**BETTENDORF CITY COUNCIL  
COMMITTEE OF THE WHOLE  
COUNCIL CHAMBERS – CITY HALL**

**TUESDAY, FEBRUARY 17, 2026  
6:15 P.M.**

The City's Standard Specifications and Standard Drawings govern the types of materials, construction methods and other details for all public improvements. These specifications and detail drawings have not been updated in nearly twenty-five (25) years.

Engineering staff has reviewed the specifications manual and created an additional document, the City's Supplemental Specifications, which modify certain SUDAS sections to better reflect our needs. Staff is requesting that the current specifications and detail drawings be replaced with the SUDAS Specifications and the City Supplemental Specifications upon approval of the ordinance, for immediate implementation.

REVISION	
	2	09/15/25
	BETT4010.201	
SHEET 1 of 2		
<p><b>SANITARY SEWER SERVICE STUB</b></p>

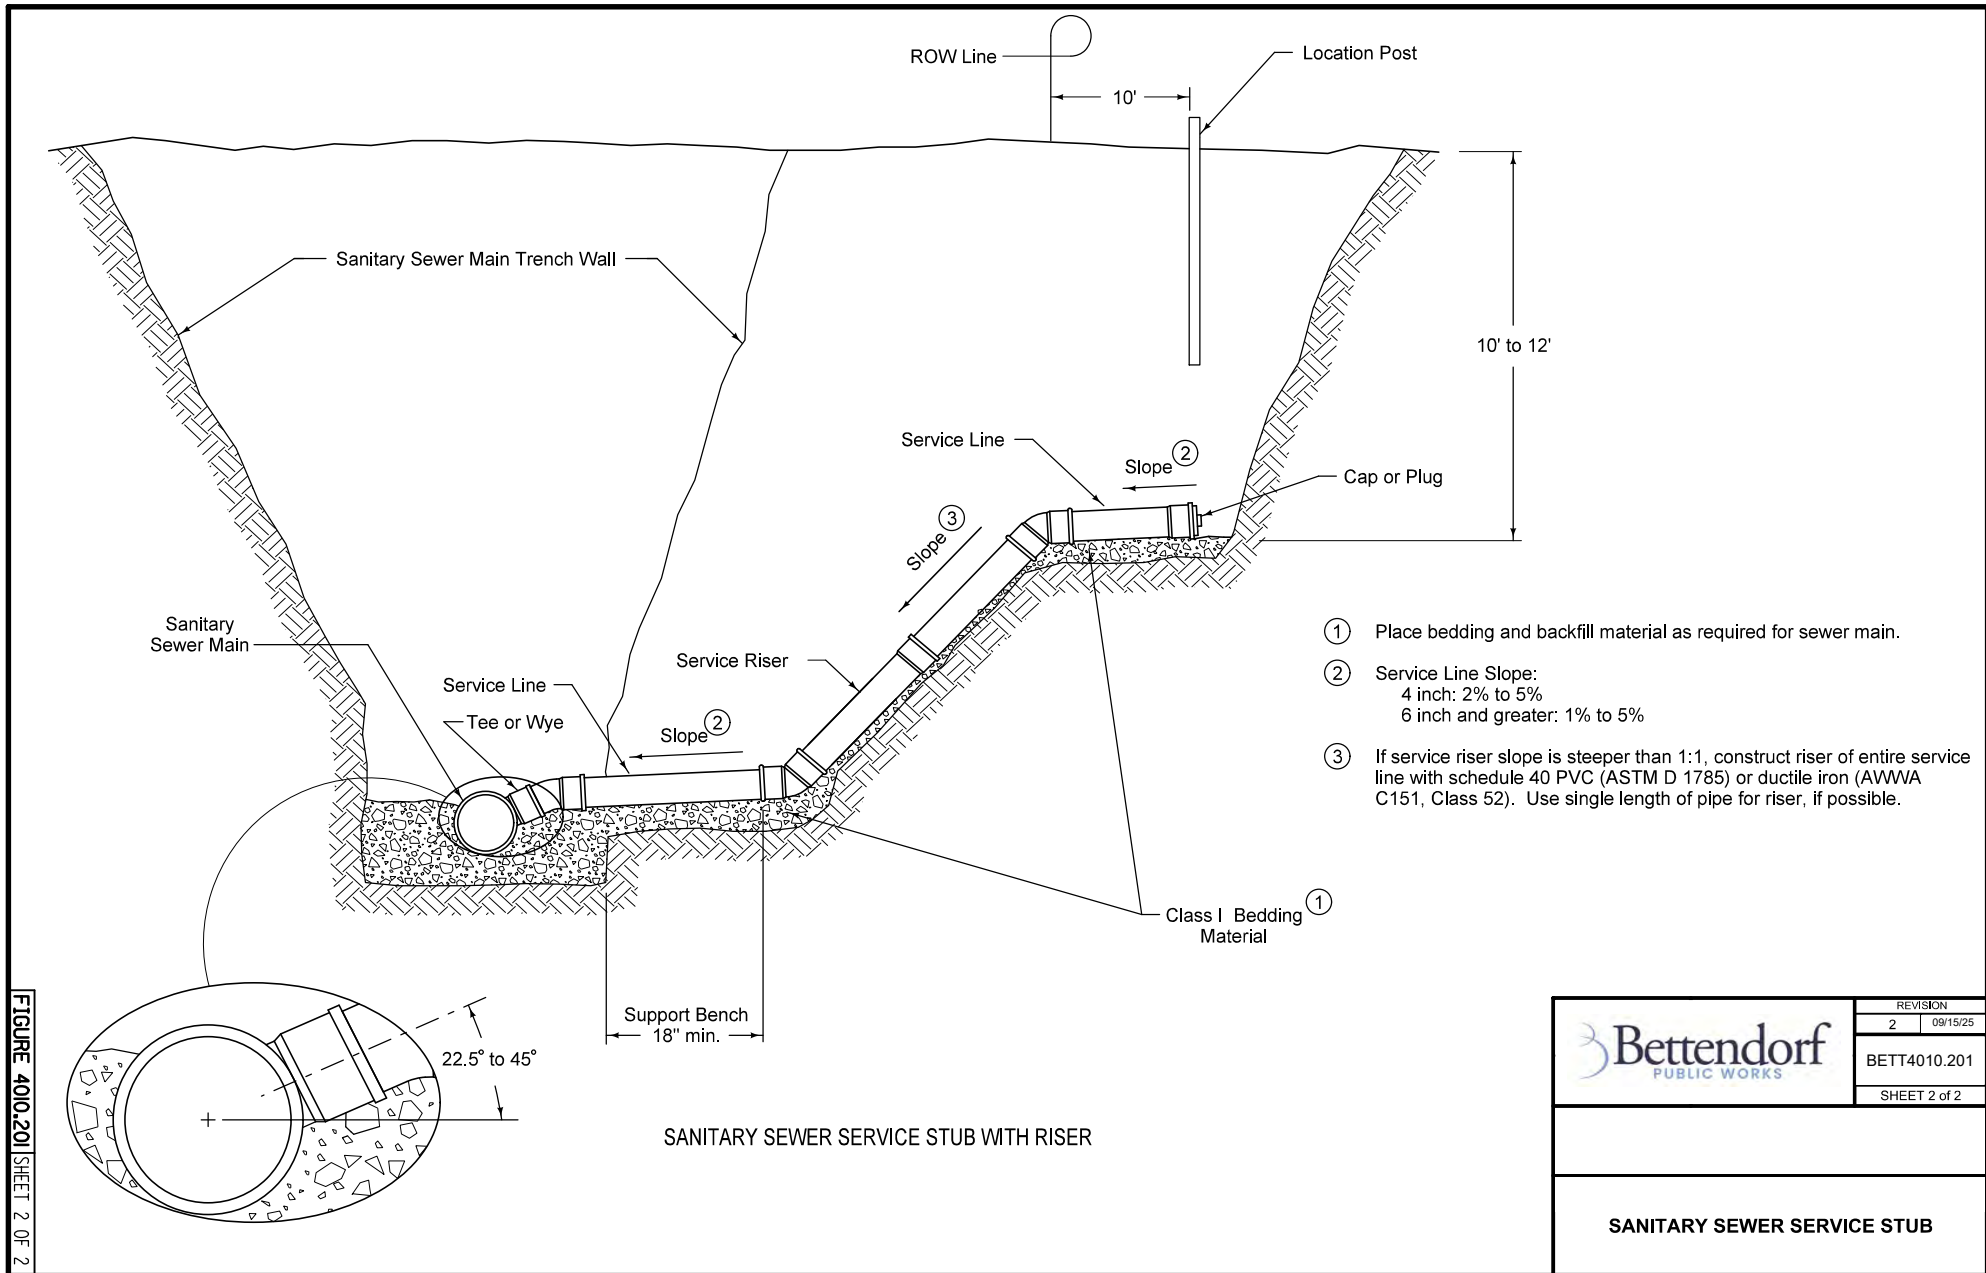
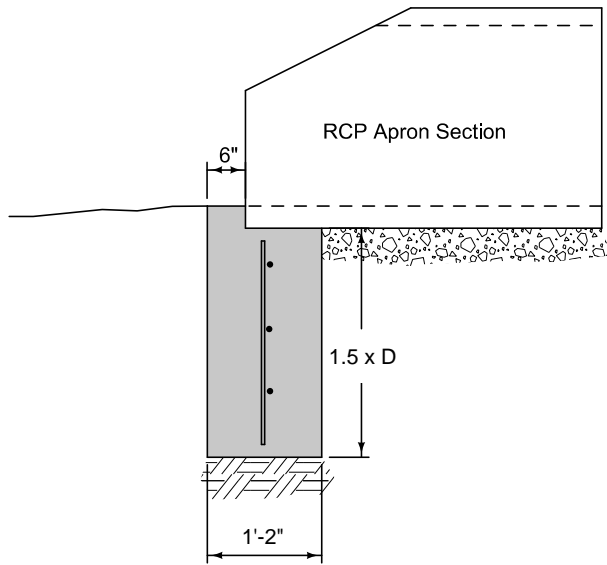
Install service stub from sewer main to the property line or to the property side of the utility easement, whichever is further, or as specified in the contract documents. Comply with Figure BETT4010.201

REPLACE Figure 4010.201 with Figure **BETT4010.201**.

REVISION	
	1	06/02/25
	BETT4030.221	
SHEET 1 of 1		
RCP APRON SECTION FOOTING

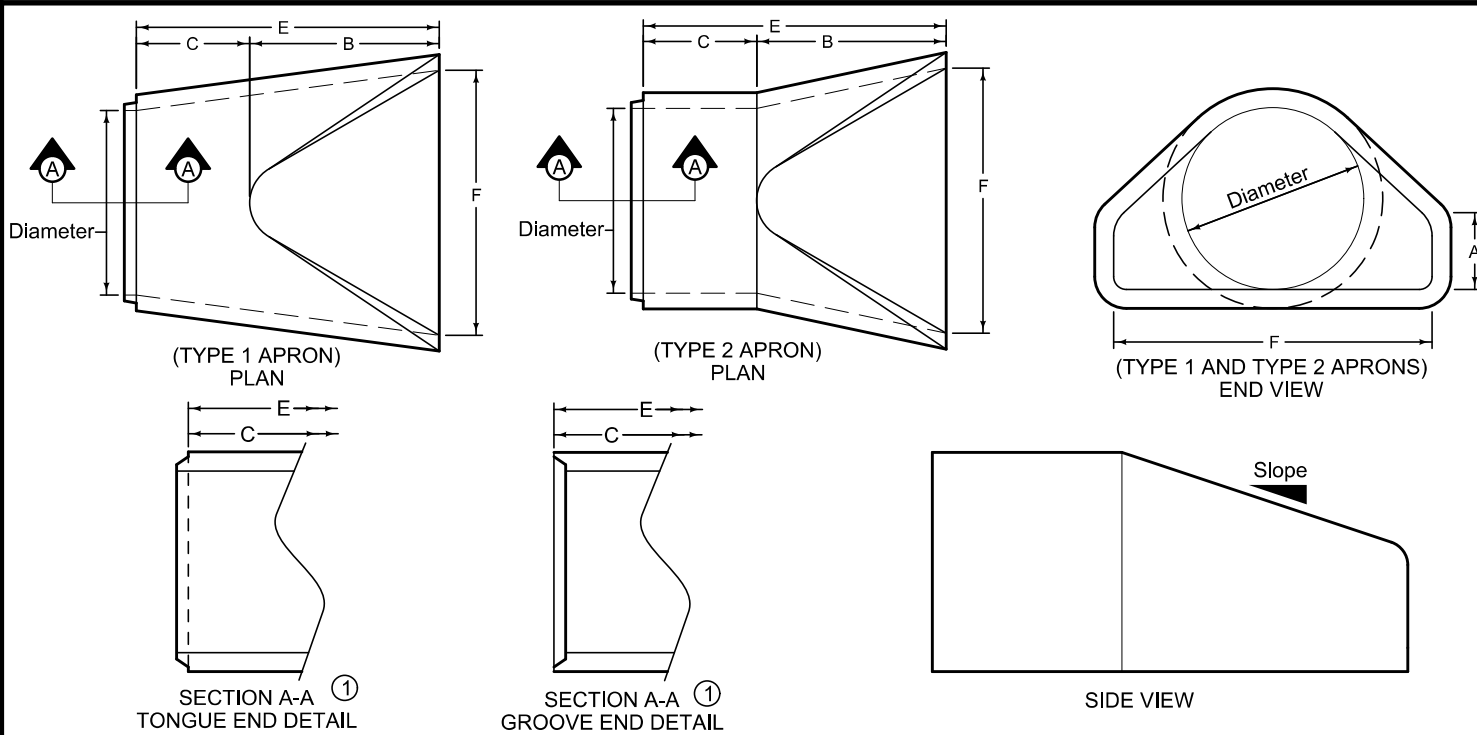
REPLACE Figure 4030.221 with Figure **BETT4030.221**

REVISION	
	New	06/02/25
	BETT4030.222	
SHEET 1 of 1		
<p>CIRCULAR CONCRETE APRONS</p>

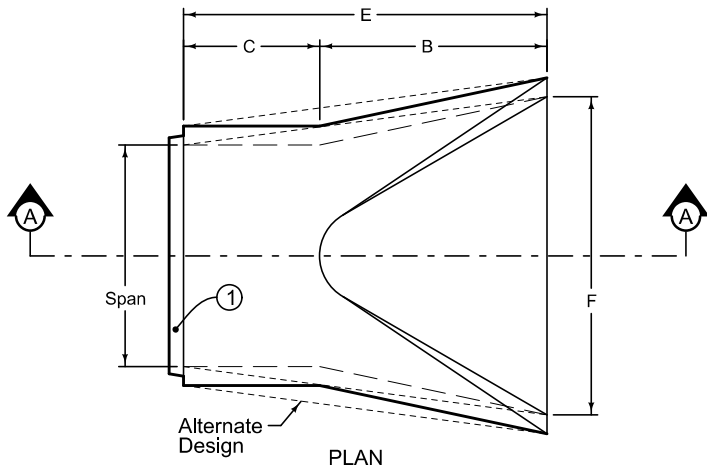
DELETE and REPLACE with the following:  
All pipe aprons must be concrete. Supply concrete pipe aprons according to Figure BETT4030.222 and Figure BETT4030.223. All storm sewer connected to pipe aprons must be reinforced concrete pipe to the nearest structure. Tie apron and next joint with pipe connectors.

REPLACE Figure 4030.222 with Figure **BETT4030.222.**

REVISION	
	1	09/10/25
	BETT4040.231	
SHEET 1 of 1

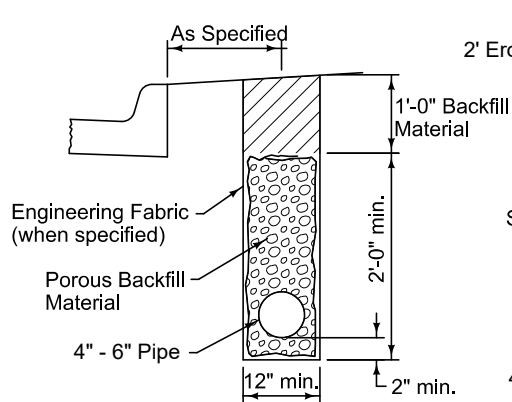
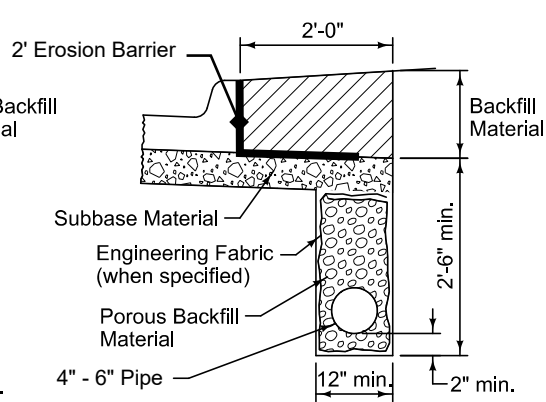
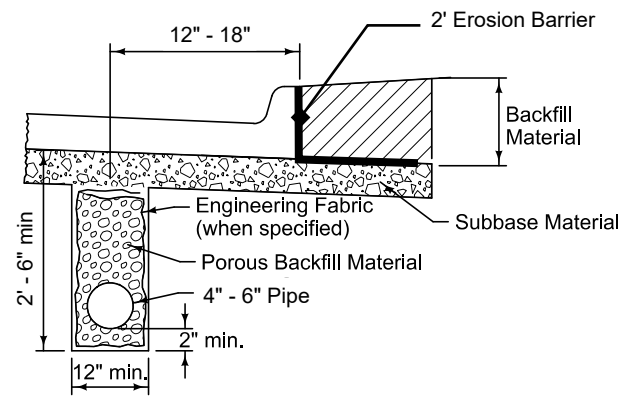
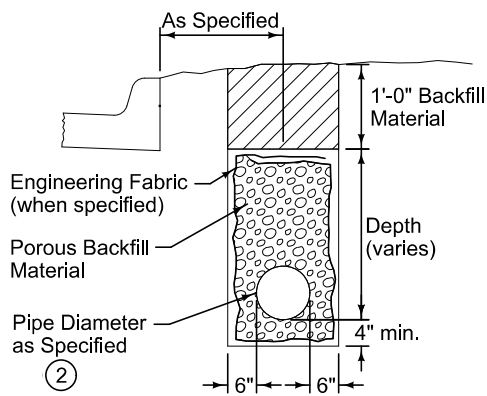
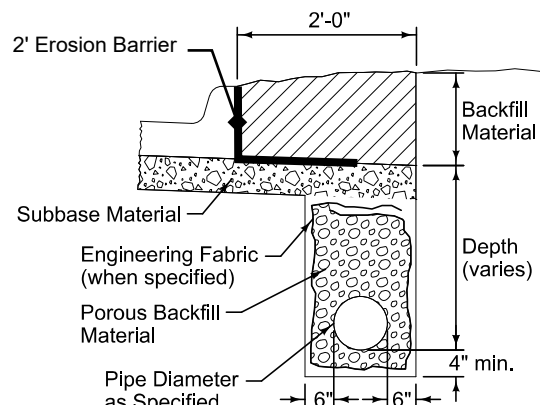
REPLACE Figure 4040.231 with Figure **BETT4040.231**

FIGURE BETT4040.234 SHEET 1 OF 1

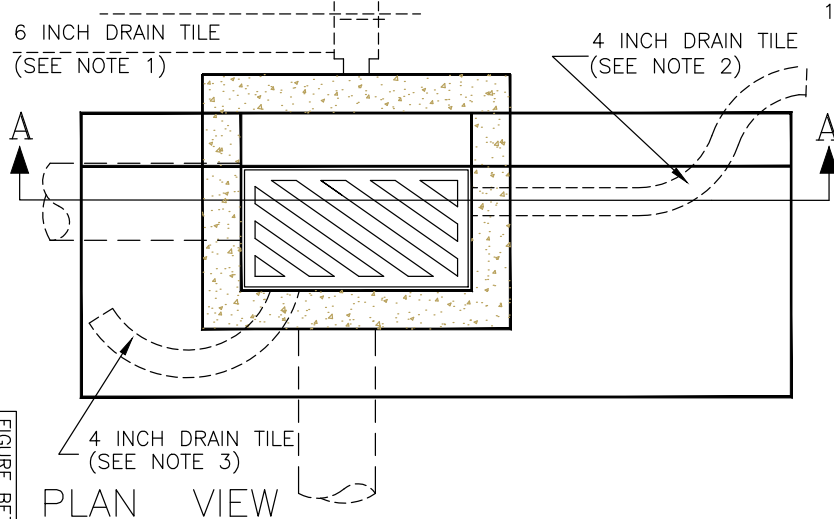
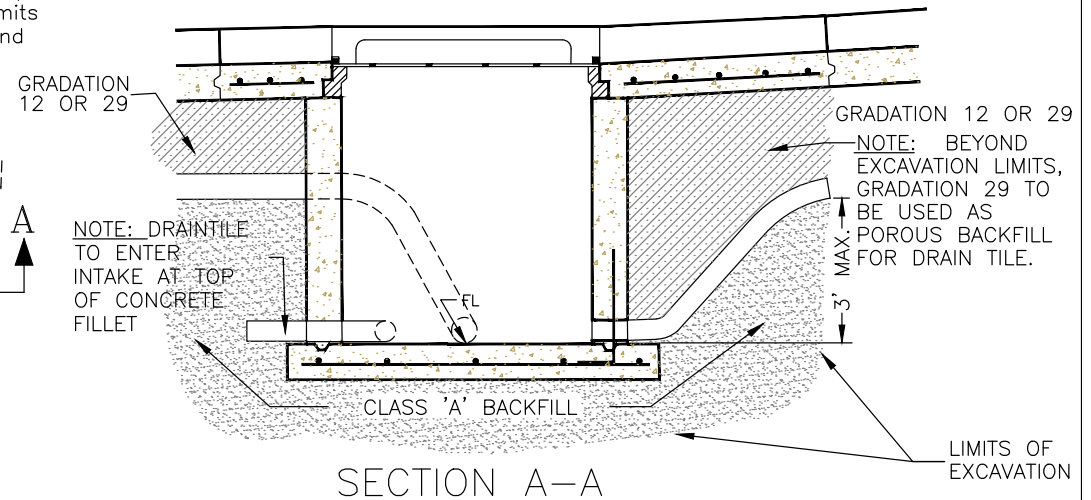
ADD Figure **BETT4040.234**.

4. ADD the following:  
Backfill intakes per figure BETT 4040.234

REVISION	
	1	05-22/25
STANDARD ROAD PLAN		BETT6010.307
		SHEET 1 of 1
REVISIONS:		
SUDAS DIRECTOR		DESIGN METHODS ENGINEER
<b>EXTERNAL DROP CONNECTION FOR SANITARY SEWER MANHOLE</b>

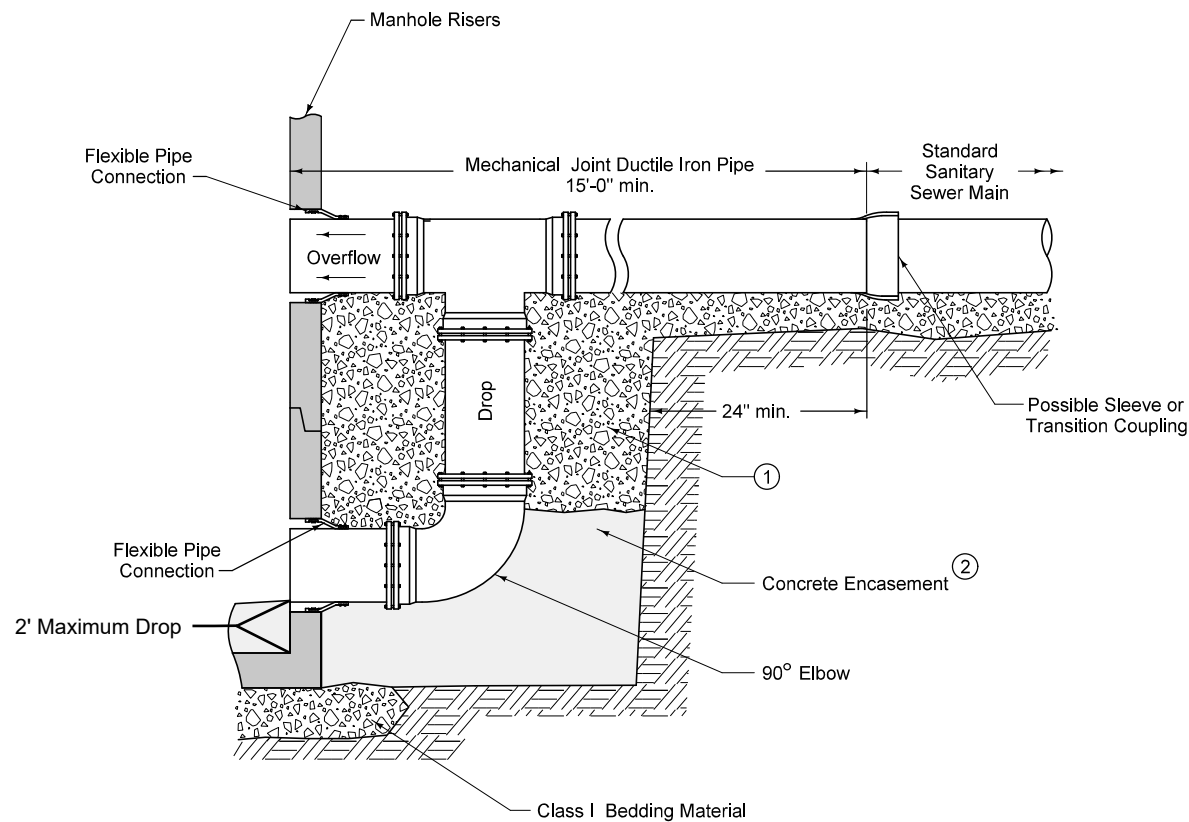
REPLACE Figure 6010.307 with Figure **BETT6010.307**.

REVISION	
	1	05-23/25
STANDARD ROAD PLAN		BETT6010.501
		SHEET 1 of 1
REVISIONS:		
SUDAS DIRECTOR		DESIGN METHODS ENGINEER
SINGLE GRATE INTAKE

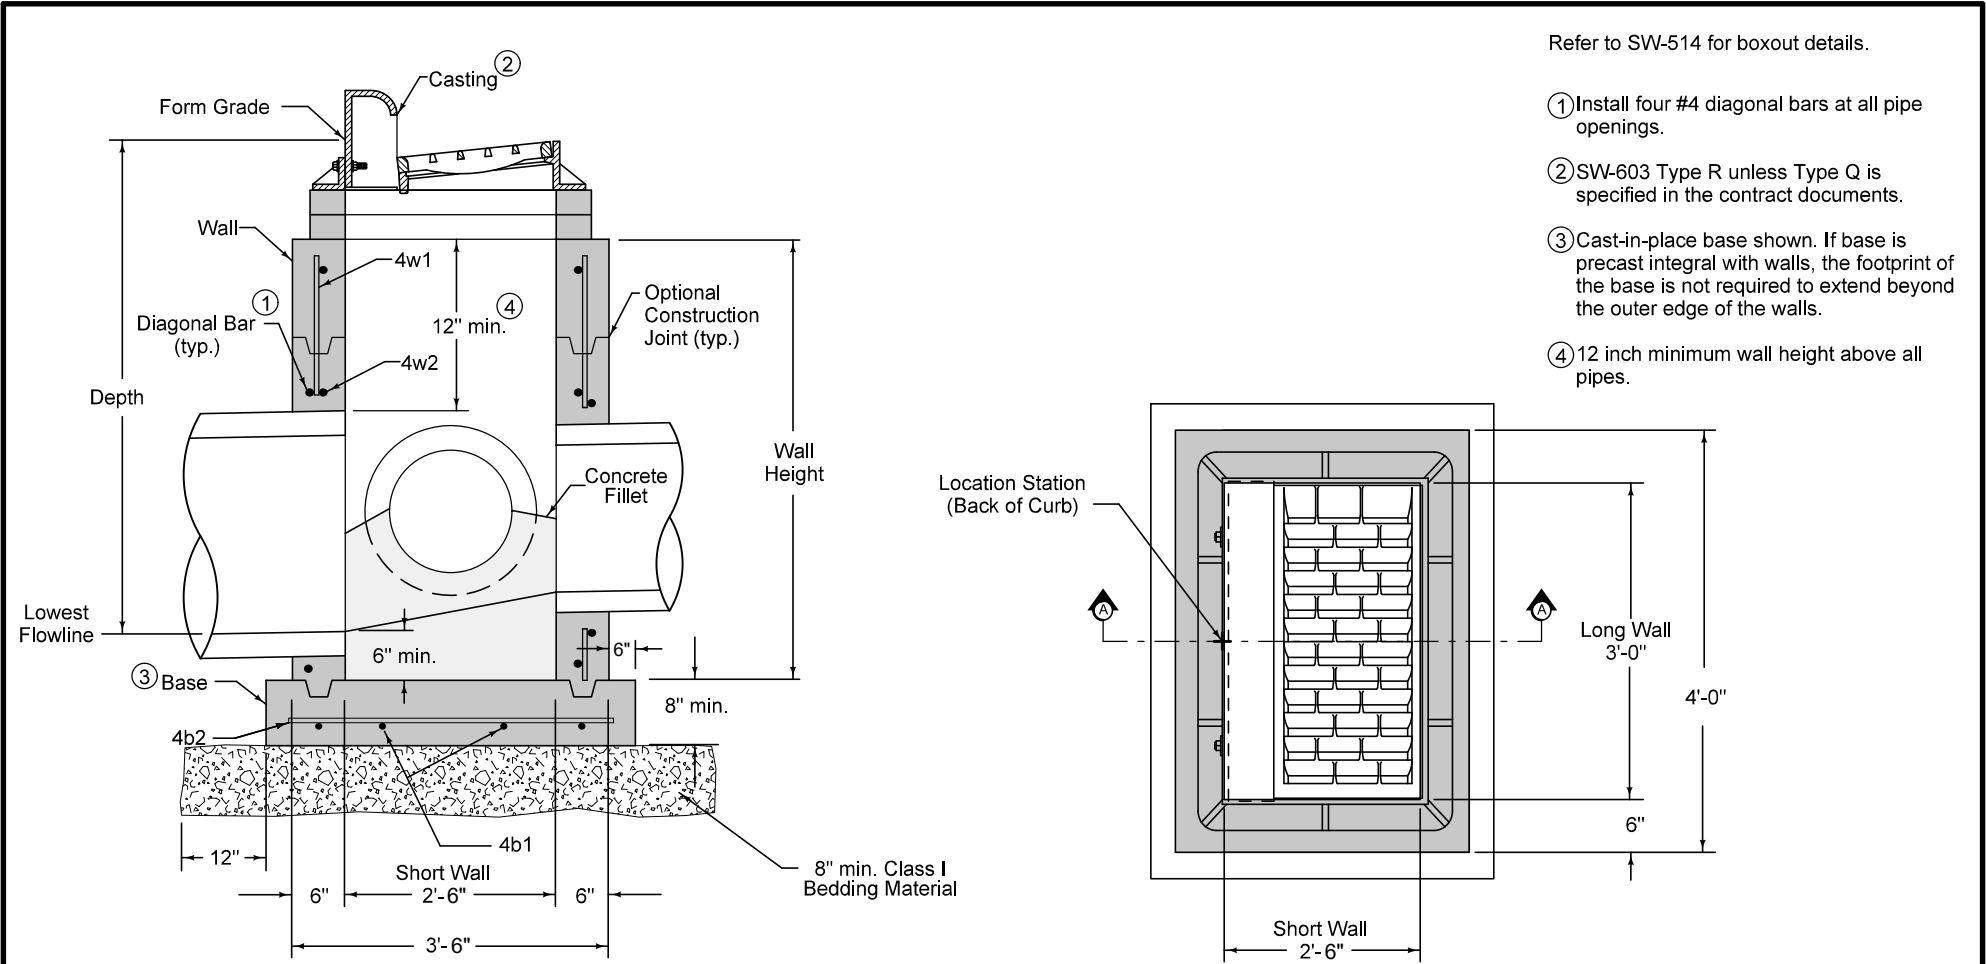
REPLACE Figure 6010.501 with Figure **BETT6010.501**
